Name: Daughters Cove Minor Subdivision – 2709 B ¾ Road

REVIEW COMMENTS

FILE #MS-96-196

TITLE HEADING: Daughter's Cove Minor Subdivision

DAUGHTERS COVE SUBDIVISION
SEWER & WATER PLAN & PROFILE

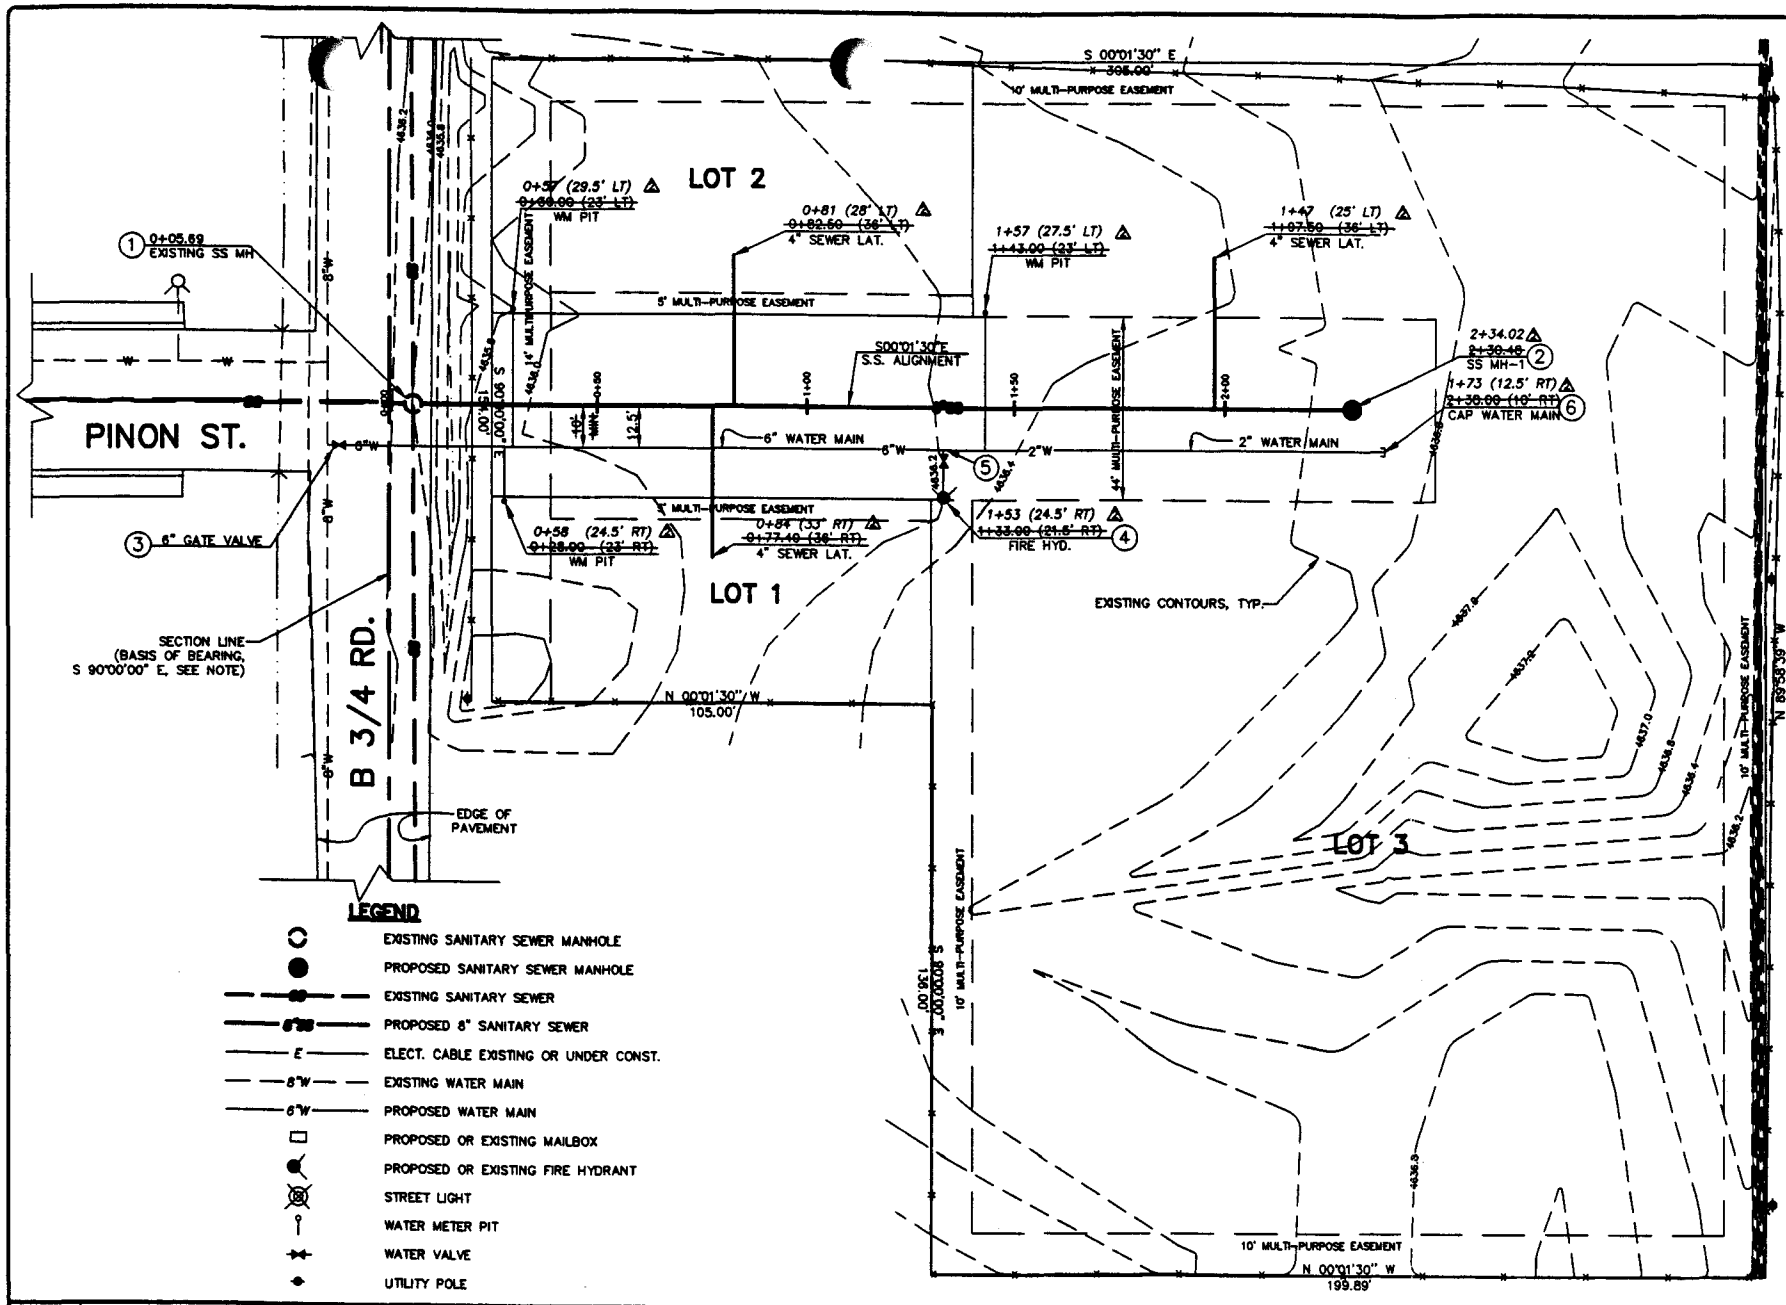
1. Review set was not signed and stamped by a Registered Civil Engineer as required.
2. Existing manhole shall be epoxy coated as it is a drop manhole which will tend to corrode quickly due to the release of hydrogen sulfide gases.
3. Proposed manhole shall have MH ring concreted in place with #4 rebar hoop when not in street per City standards.
4. Increase slope on sewer extension to +0.60% due to the low amount of flow that will be generated from this development.
5. A minimum of 6' of cover shall be maintained over sanitary sewer mains and a minimum of 3' over sanitary sewer service lines.
6. Add following water notes:
 - a. Water meter pits and yokes will be furnished by the City of Grand Junction for installation by contractor.
 - b. Water meter pits shall be place 2' behind any planned sidewalk.
 - c. Minimum cover for all water mains and service lines is 4 feet.

GOOD TO GO.

DAUGHTER'S COVE MINOR SUBDIVISION
MS-96-196

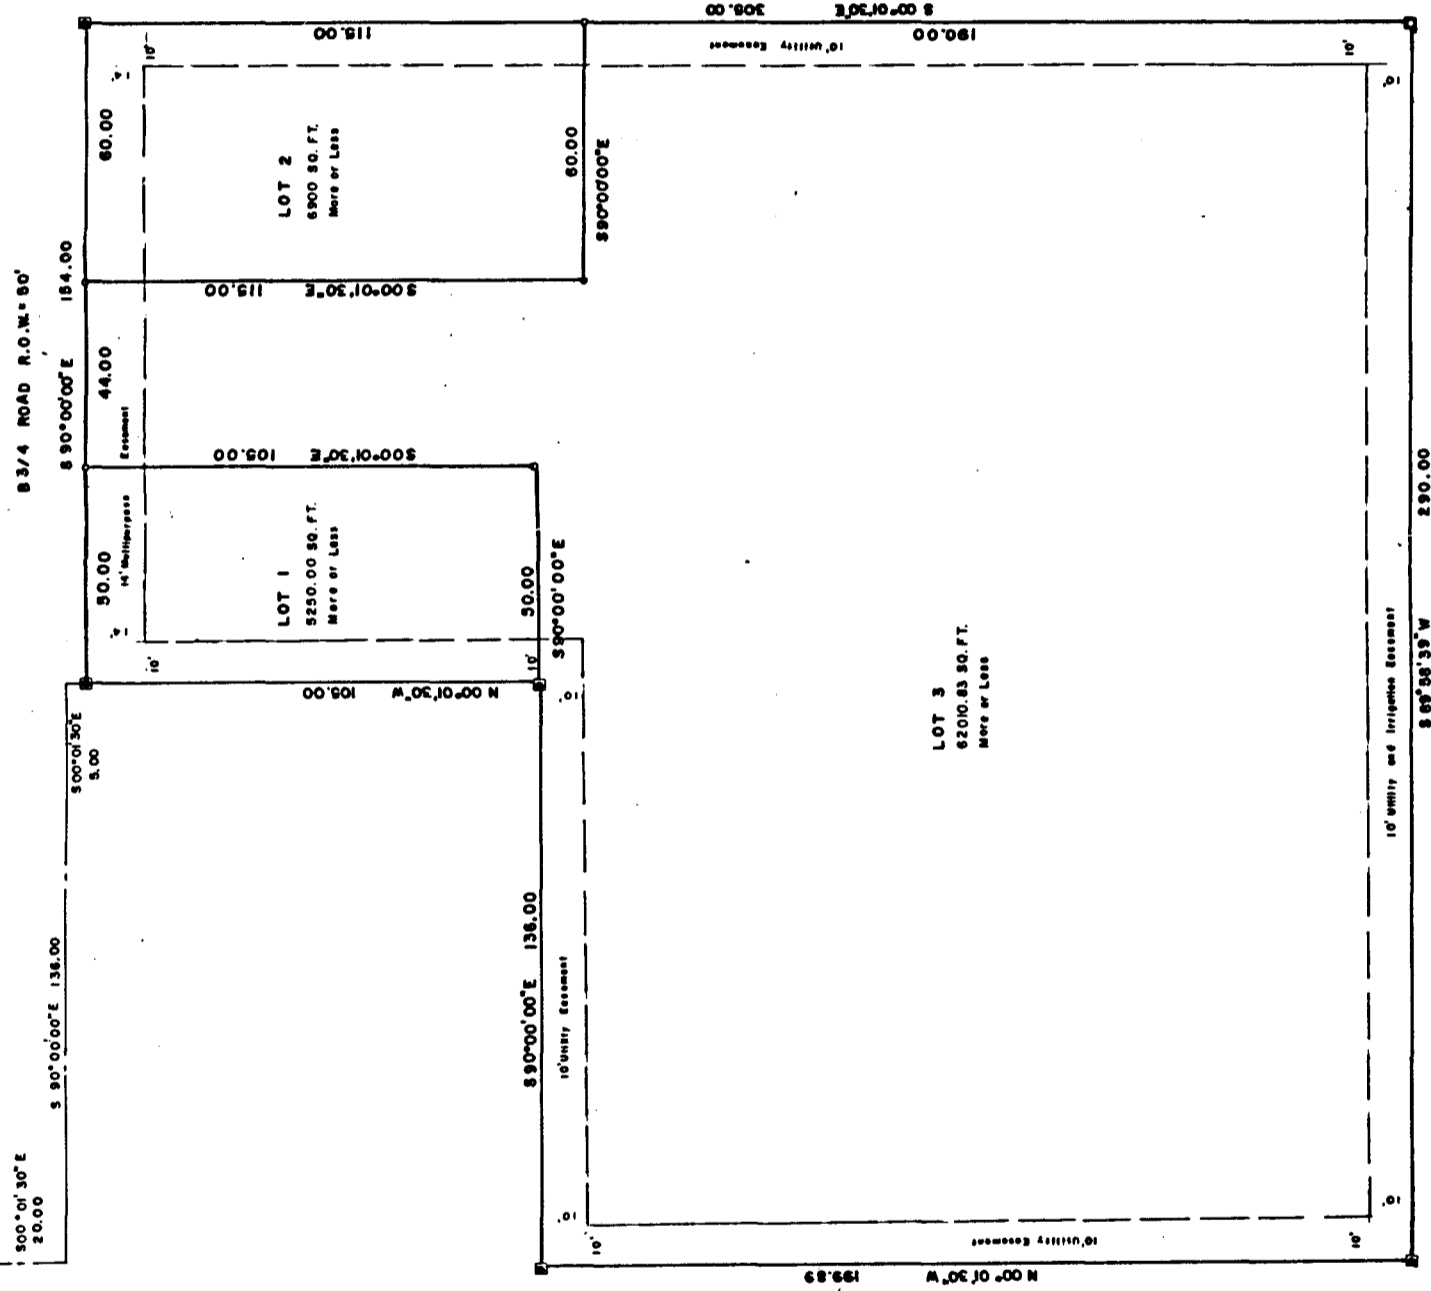
1. Show centerline of Pinon St to the north to assure that it aligns with lot 3.
2. Remove dedication statement for B 3/4 Road since no right-of-way is been dedicated. Add a dedication statement for the multi-purpose easement and irrigation easement. Remove the dedication statement for the ingress\egress easement since none is provided.
3. **NOTE:** Please submit an 11" X 17" copy of the plat with corrections, along with the 4 full size copies in your response to comments.

1. Does lot 3 street frontage line up with Pinon St.?
2. Please use the City's Guide to Plat Dedications for the plat dedication language.
3. The drainage fee as calculated is acceptable.

1. The basis of bearings should show the bearing between (2) found monuments along the north line of the NW1/4 SW1/4 NW1/4 of Section 25.
2. Need to address multi-purpose easements in the dedication.

3. Ingress/egress easements are addressed in the dedication but are not shown on the plat.
4. South line of Lot 3 shows S89°58'39"W; the description shows N89°58'39"W.
5. You can remove verbage pertaining to drainage, detention/retention easements from the dedication.
6. The are for Lot 3, and total are, seems to be slightly in error.
7. Label the P.O.B. (Point of Beginning) on the plat.

1. Revise plat to show the frontage of lot 3 centered on the centerline of Pinon Street.
2. Add a 5 foot wide multi-purpose easement along the sides of lot 1 and lot 2 for future utility extension, if necessary.
3. Remove the dedication language for the ingress-egress easement. Replace "aligns" with "assigns" in dedication language, last paragraph.
4. Place the following note on the plat to advise future property owners of the possibility for the extension of Pinion Street: "Lot 3 has been configured to allow possible extension of Pinon Street in the future to serve additional lots."
